**CITY OF PHOENIX PLANNING COMMISSION**  
**Regular Meeting and Public Hearing**  
**Monday, December 11, 2023**

6. **New Business:**
  - a. Election of Planning Commission Chair
  - b. Public Hearing: SP23-05, VAR23-01, FP23-02, LL23-02 – Arroyo, Multi-family development (pg 5)

**File: SP23-05 – Site Design Review**  
**VR23-01 – Variance**  
**FP23-01 – Flood Plan Development Review**  
**LL23-02 – Lot Line Adjustment**

Request for Site Plan and Architectural Review for an 18-unit, multi-family residential apartment development. There are two, two story structures proposed. Building A has ten units and Building B is proposed to have eight units.

Revision No.	Date
Project ID	1957
Client Name	Estevan "Steve" Arroyo
Drawn By	JML
Reviewed By	JML
Date	10/18/2023
Sheet Title	PROPOSED SITE PLAN
Sheet No.	L0.0

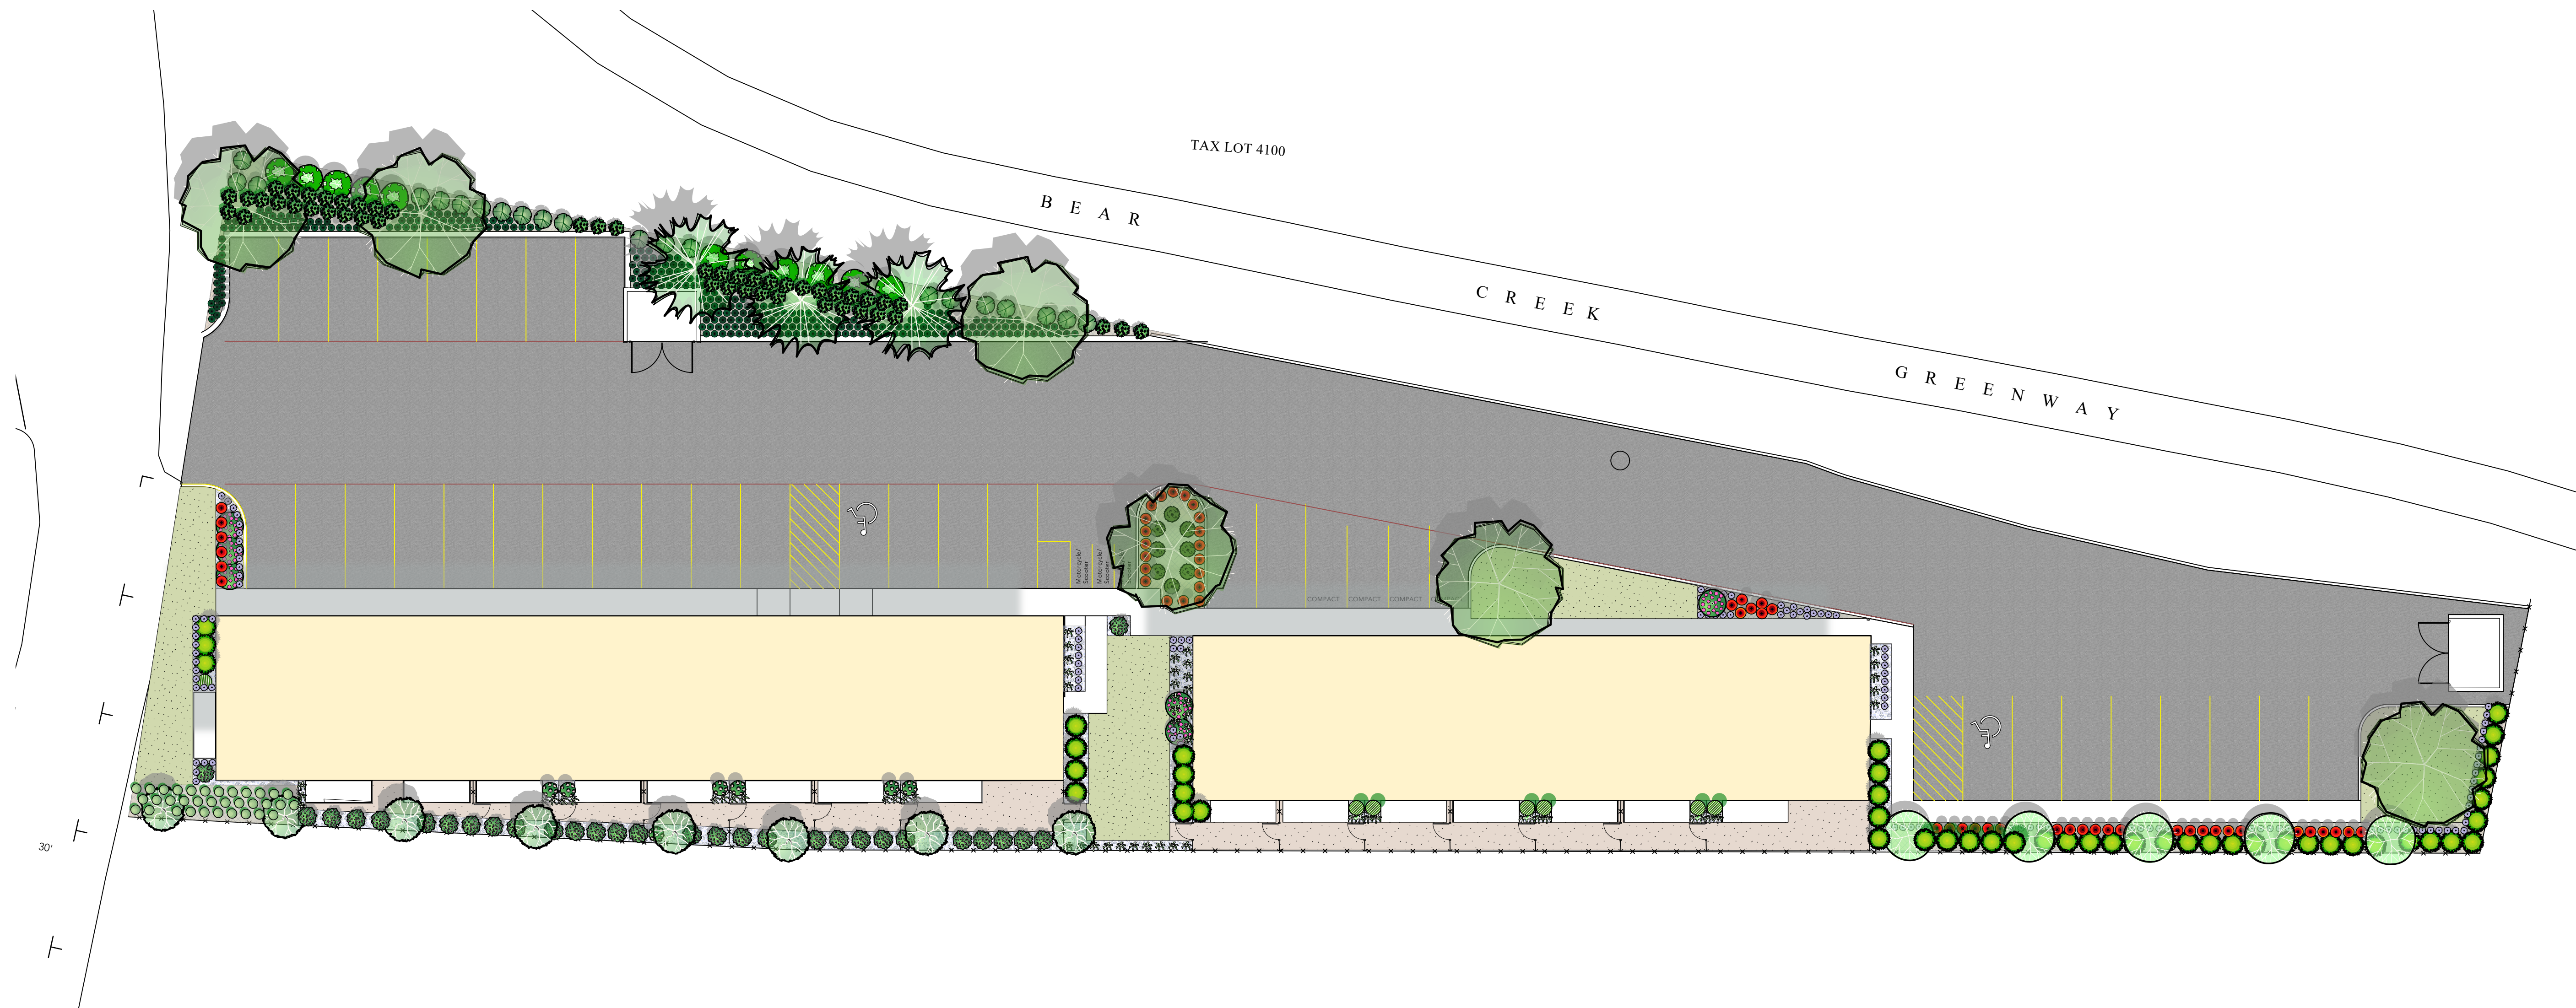
**FINDING:** (A & B) The proposed development is subject to Site Design Review. A Landscape Plan (L0.0-L1.2, 10/18/23 revision) has been submitted as part of this application. (C) The development, being in a residential district, requires a minimum of 20% landscaping. The site measures approximately 36,891ft<sup>2</sup>. As proposed, 8,318 ft<sup>2</sup> -or- 22.5% of the site is landscaped. (D) According to L1.0 and L1.1, Landscape materials include a mix of trees, shrubs, ground cover plants, non-plant ground covers, and outdoor hardscape features. **The standards are met.**

**FINDING:** (1) The Proposed Landscape Plan (L0.0-L1.2, 10/18/23 revision) provides sufficient landscaping to meet the criteria of subsection A-H. (2) Neither the applicant's narrative nor the proposed Landscape Plan indicate the parking area perimeter and portion that is landscaped. However, a GIS analysis of the proposed parking area (parking spaces and maneuvering areas) indicates a parking area perimeter of approximately 1,000 ft. Of that, approximately 38% -or- 380 ft contain an evenly distributed mix of shade trees with shrubs and/or ground cover plants. The proposed Site Plan (A1.0, 9/14/23 revision) shows thirty-seven (37) parking spaces, which calls for a minimum of eight (8) trees; L1.1 shows that twenty-two (22) trees are proposed. The Site Plan and Landscape Plan reflect the presence of a landscape island, which is necessary to break up parking areas with more than 20 spaces. The proposed landscape island measures approximately 13 ft by 19 ft and the landscape plan includes a dense planting of varying sized trees. (3)(a) Because parking and maneuvering areas are proposed to be adjacent to ground floor living space, a landscape buffer is required between the parking area and the building. The pathway and landscape buffer combined, must measure no less than eight (8) ft in width. As a condition of approval, prior to submittal for building permits, the applicant shall submit a revised site plan and landscape plan that shows a landscape buffer and pathway between the parking area and the residential ground floor living space; the pathway shall measure no less than 6 ft and the landscape buffer shall measure no less than 2 ft. (b) Details on mechanical equipment have not been provided in the applicant's submittal. All mechanical equipment will need to be screened from view from all public streets and residential districts. As a condition of approval, prior to issuance of permits, planning staff will review construction plans to ensure that all mechanical equipment has been screened from view. **The standards are met with conditions.**
